LAYOUT HISTORY

LAYOUT No. 1A COPY No.

T.H. 60 VICINITY OF CITY OF HERON LAKE

FROM 0.2 MILES WEST OF C.S.A.H. 24 TO 0.1 MILES EAST OF C.S.A.H. 43

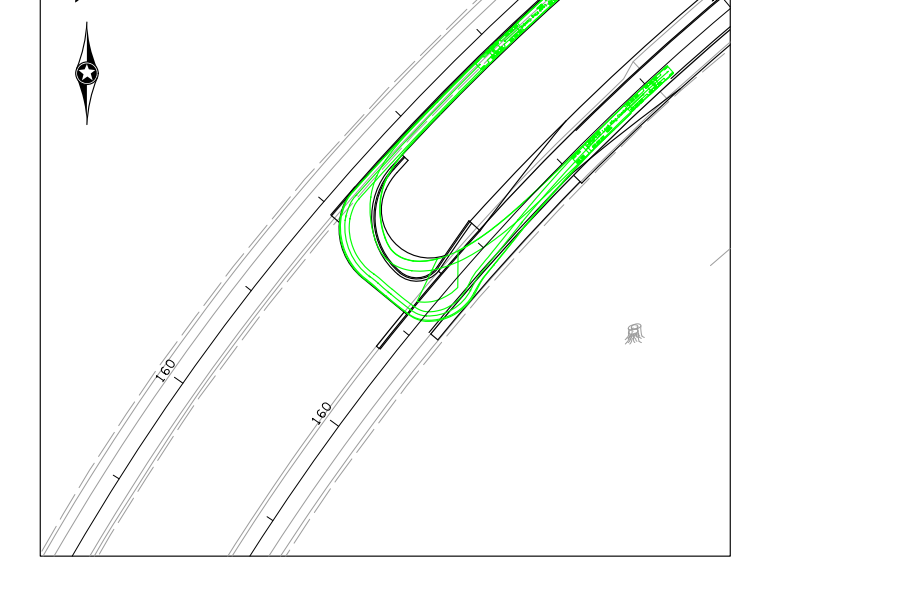
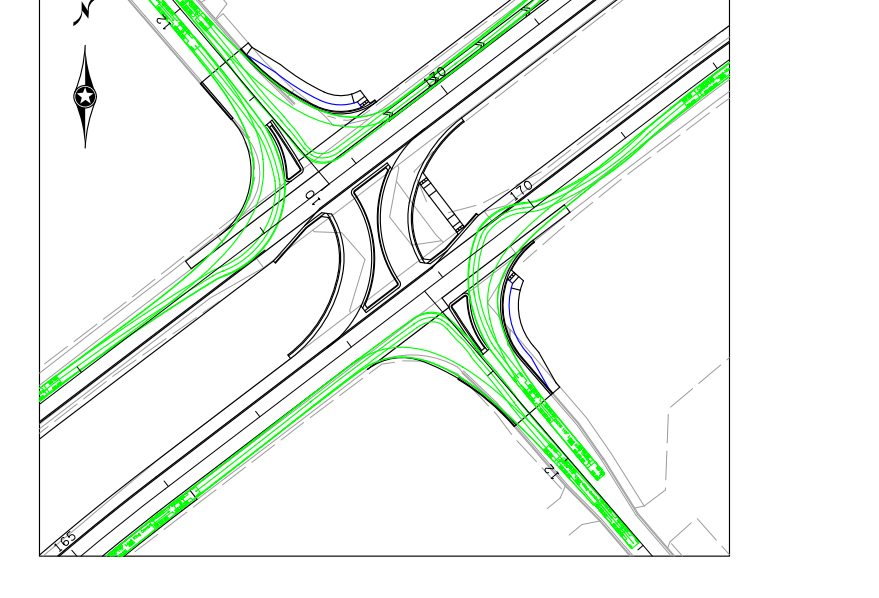
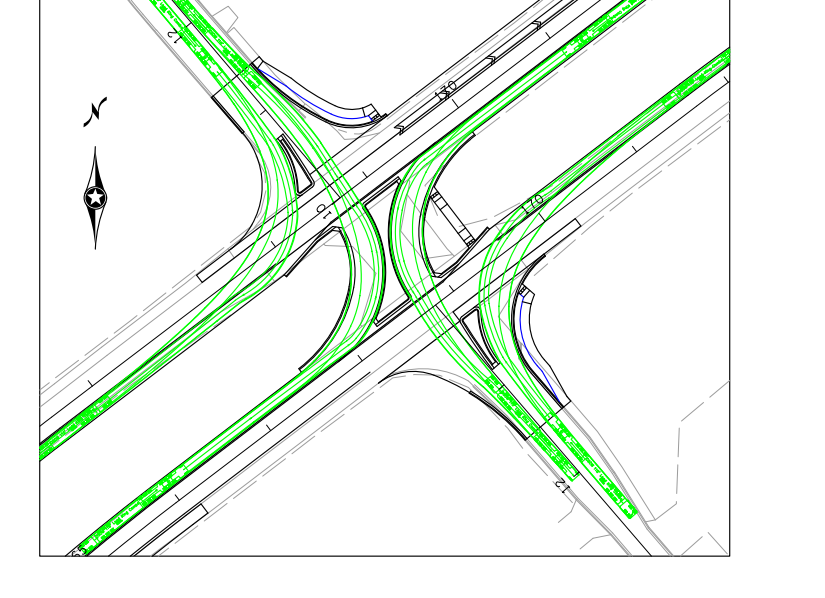
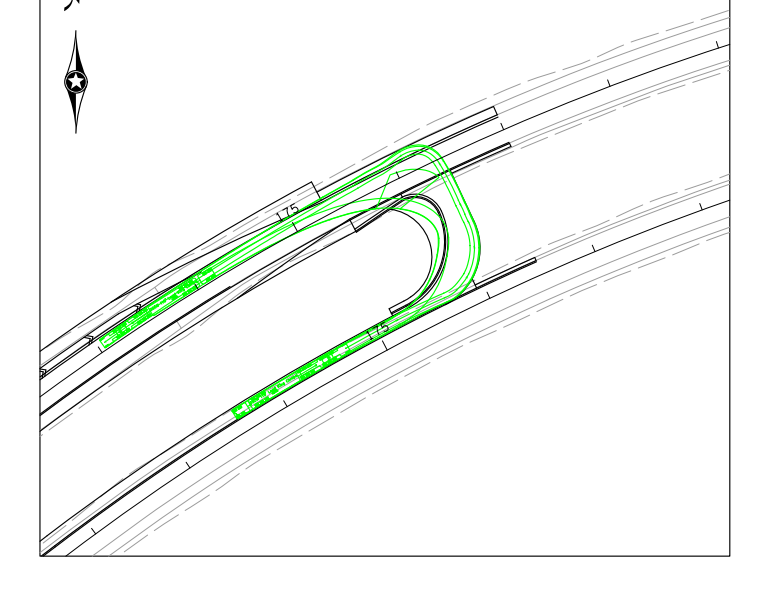
LAYOUT NO.1 IS SUBMITTED SHOWING 600 FT FULL WIDTH RIGHT TURN LANES. ALLIANT RECEIVED COMMENTS FROM MNDOT DISTRICT 7 TO REVISE THE FULL WIDTH RIGHT TURN LANE LENGTH TO 450 FT. ADDITIONALLY, MNDOT GDSU COMMENTED TO USE A TRUCK APRON AT THE C.S.A.H. 9 MUTS TO PROVIDE THE TRACKING AREA FOR THE LOAD KING VEHICLE MOVEMENT. MNDOT GDSU ALSO COMMENTED TO MODIFY THE GEOMETRY AT THE C.S.A.H. 9 RCUT TO REDUCE THE WIDTH. MNDOT CO ADA GROUP COMMENTED TO MODIFY THE GEOMETRY OF THE SIDEWALK WITHIN THE MEDIAN AT C.S.A.H. 9.

LAYOUT NO. 1A IS SUBMITTED SHOWING 450 FT FULL WIDTH RIGHT TURN LANES. ALSO, ALL MUT LOCATIONS ARE ADJUSTED DUE TO REVISED RIGHT TURN LANE LENGTH TO BE LOCATED AS CLOSE TO THE INTERSECTION AS POSSIBLE WHILE STILL MAINTAINING 50 FT FROM THE NEAREST TURN LANE. TRUCK APRONS WERE ADDED TO THE C.S.A.H. 9 MUTS. ALSO THE GEOMETRY AT THE C.S.A.H. 9 RCUT WAS UPDATED TO REDUCE THE WIDTH AND PROVIDE A MOUNTABLE C&G FOR THE LOAD KING VEHICLE TO TRACK ONTO. THE SIDEWALK GEOMETRY IN THE MEDIAN AT C.S.A.H. 9 WAS ALSO MODIFIED TO PROVIDE A PERPENDICULAR CROSSING OF T.H. 60 W.B.
